TABLE OF CONTENTS

Statements of Staff Position

1. Fire Protection Program - Organizational Chart

NINE MILE POINT SITE FIRE PROTECTION INTERFACES

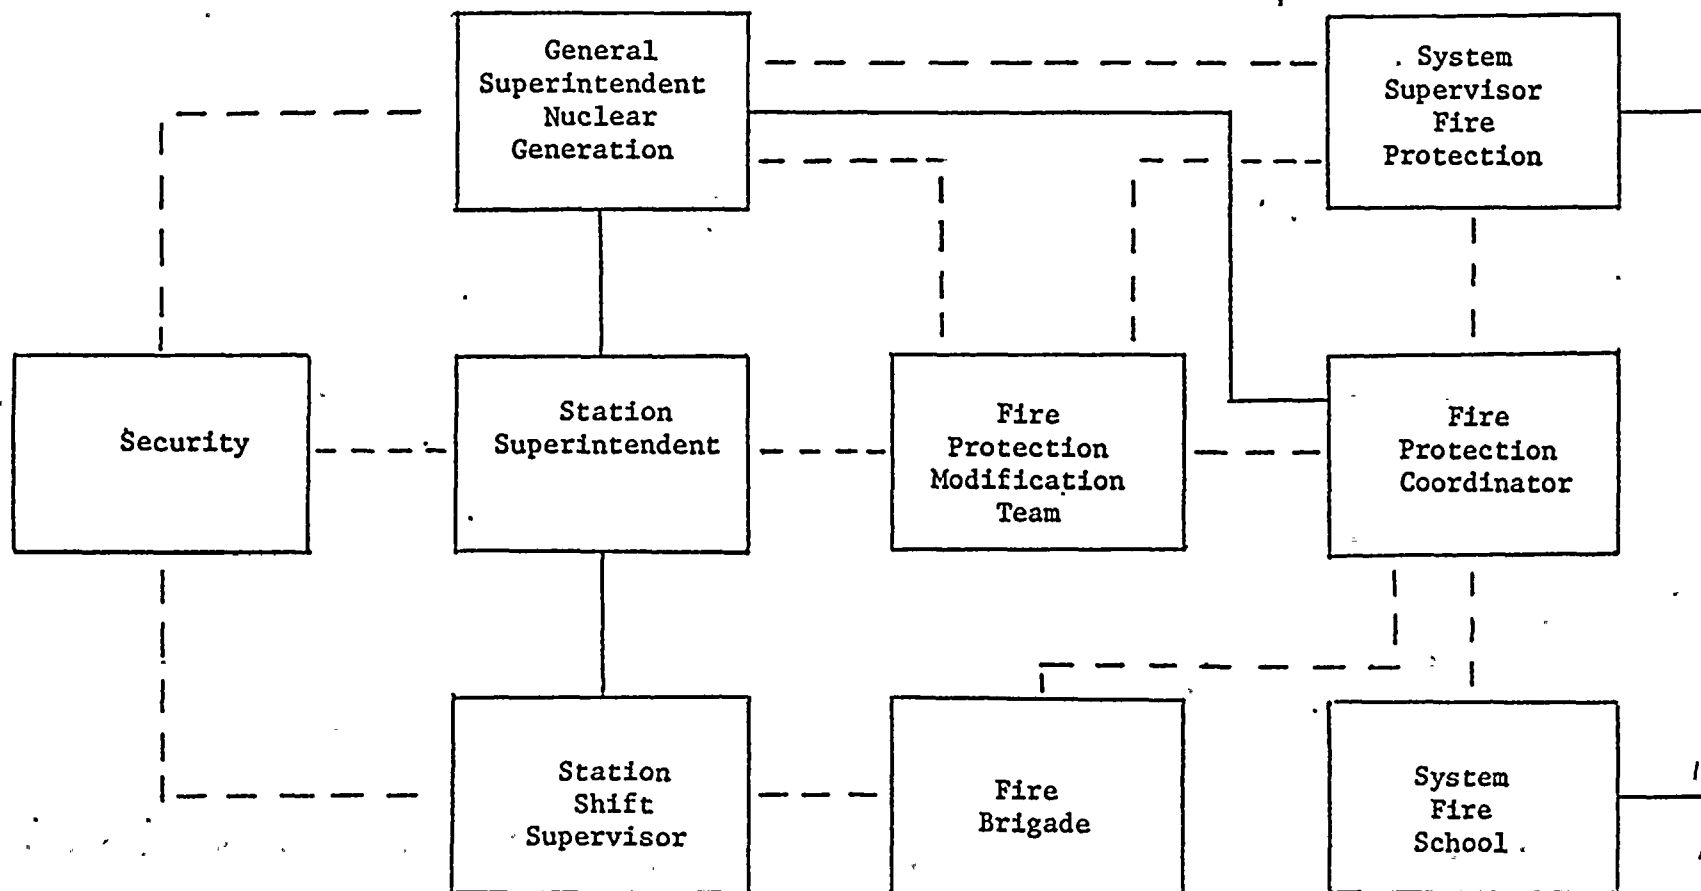
Provide an organizational chart of the offsite and onsite personnel involved in the fire protection program.

The attached figure shows the interfaces of the Nine Mile Point fire protection program.

STATION FLOOR PLAN BETWEEN ELEVATIONS 317' - 0" AND 369' - 0"

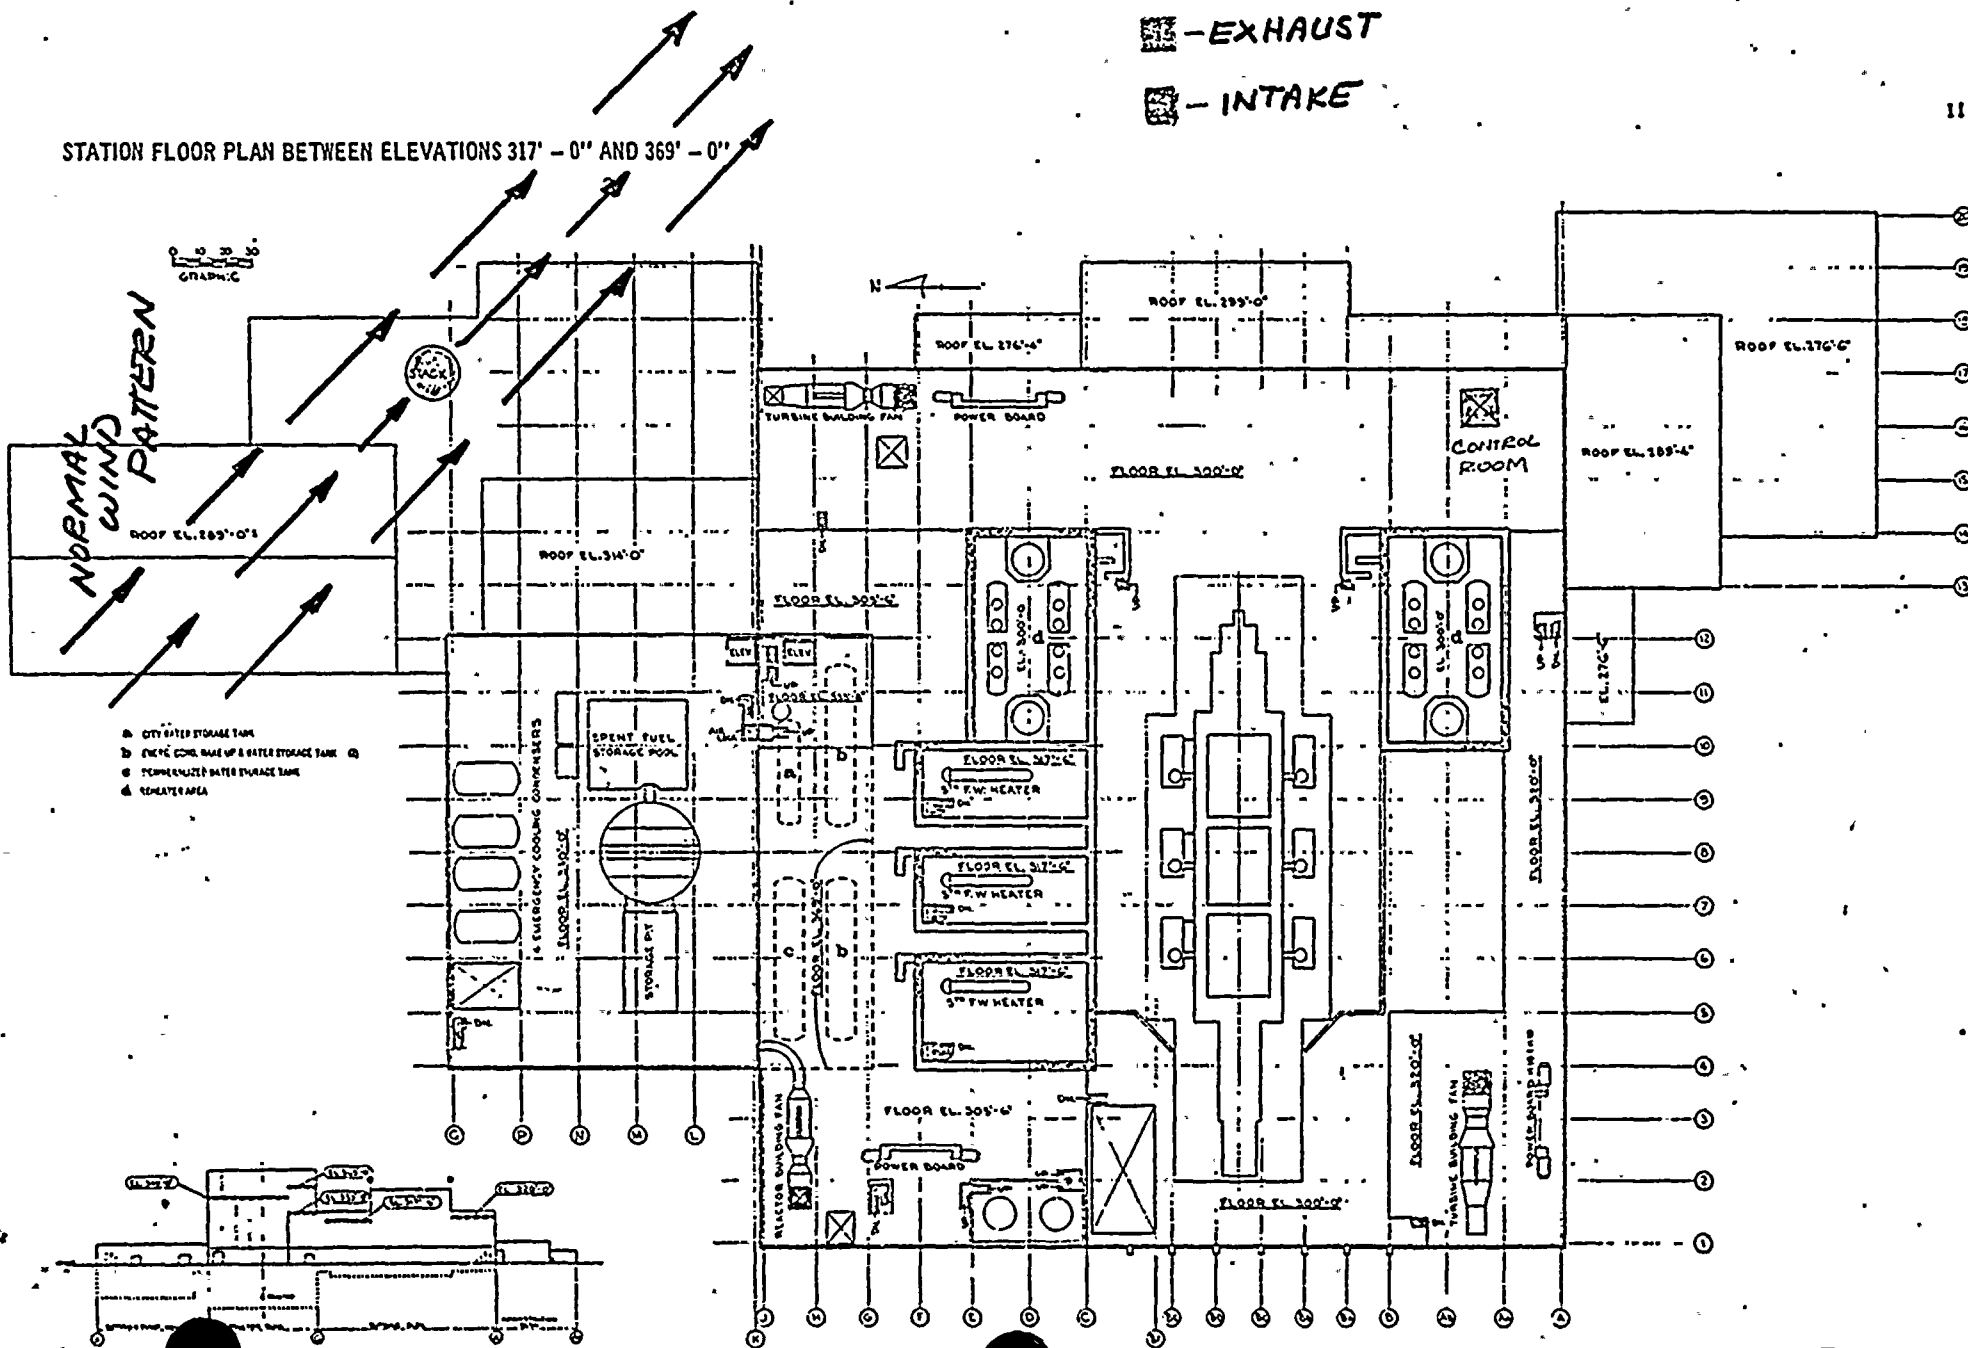
Describe the separation between the air intakes and exhausts for normal and emergency ventilation systems and the current and proposed provisions which prevent smoke from being drawn back into the plant.

The plant design and configuration is such that the exhaust is expected to be carried away from the plant air intakes (see attached). All the exhaust air from the plant under normal ventilating conditions and for small fires that can be handled by the normal ventilation system is released from the stack. The stack is over 170 feet above all of the supply intakes, and with a gas exit velocity of 63 feet per second, sufficient dispersing should occur.

In the circumstance of a fire in the turbine building in which the roof vents were used as a method of exhausting smoke, should the turbine building supply fans begin to draw smoke in, these fans could be turned off and two large doors at ground level could be opened for sufficient supply. Should the control room intake begin to draw significant amounts of smoke, it will be possible to shut off the supply fan and open a door into the administration building to supply air and use the exhaust fan mounted on the smoke shaft for air removal. This would maintain visibility in the control room. The location of the reactor building intake provides adequate separation from the stack as well as the roof vents under normal conditions. Should some smoke migrate to the reactor building intake, this would be tolerable. A great deal of smoke would necessitate shutting off the supply fan. This will cause a more negative pressure in the reactor building.
